REVIEW #1

first, thank you for reviewing our manuscript for ESSD. We appreciate your voluntary work during pandemic times which enables us to still publish research and make the EasyGSH-DB data collection available to the public. Let us answer to your remarks below.

Answers:

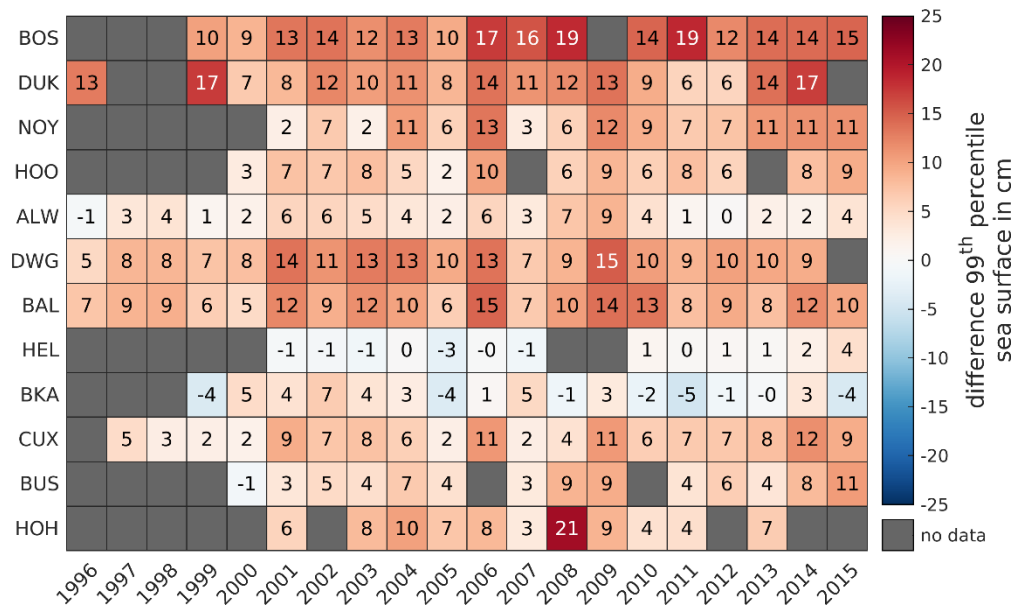
2. The domain of the hydrodynamic model basically covers the North Sea and the authors briefly mention that some calibration was made to account for surges at the open boundaries. Some more details are needed, for example, what data were used and how was the calibration made? Can this set-up account for the effects of external surges? What are the impacts on extremes?

Answer: We suppose this refers to L131-134 of the original manuscript. The external surge is calculated from differences between calibrated hydrodynamics and sea surface measurements. Let us take you through the external surge assimilation process as documented in Plüß (2003):

- (1) Hydrodynamic calibration of the model
- (2) Calculation of differences between model result and measurement near open boundary
- (3) Smoothing of those differences by running average
- (4) Adding the smoothed differences onto the open-boundary water level signal
- (5) Re-running the model
- (6) Repeating step (2-5), until satisfying agreement is reached or differences are near zero.

We used tide gauges from Roscoff (France) for the southern open boundary, and Helgoland (Germany) for the northern open boundary. We are aware that Helgoland is quite far away from the northern boundary but our model simulations showed much better agreement to measurements with Helgoland than with Lerwick or Aberdeen (both Scotland), similar to the results of Plüß (2003) and Heyer (2015). Also, sea surface measurements in Lerwick and Aberdeen suffer from numerous data gaps throughout the product time-span which makes their application quite cumbersome. External surge calculated in Helgoland and Roscoff includes a time-lag corresponding to the average propagation speed of the tidal wave. The entire process needs to be repeated 2 to 7 times each year to catch smaller surge fluctuations and to improve extreme events.

To answer your questions: We expect that our setup fully includes external surge for fair-weather and extreme conditions alike (also see our answer to 3). We believe the model calibration process to be redundant in this paper, as we want to focus on the data product validation rather than modeling. Many aspects of the calibration (e.g. parametrization or bottom roughness) are documented separately in BAW Technische Berichte (2020) which can be downloaded from the EasyGSH-DB website (or via DOI: [10.18451/k2_easygsh_1](https://doi.org/10.18451/k2_easygsh_1)).

Action: We added additional information about the external surge approximation process and iteration as well as the benefits to our data in the beginning of Sect. 2.2 (around L135). Specifically, we added that surge is calculated separately at the northern and southern open boundary by smoothed water level differences, and that we reiterate surge, until these smoothed differences are near zero. We have also elaborated on the benefits of this procedure, as sea level rise, external surge, and every other water level fluctuation is considered in our data.
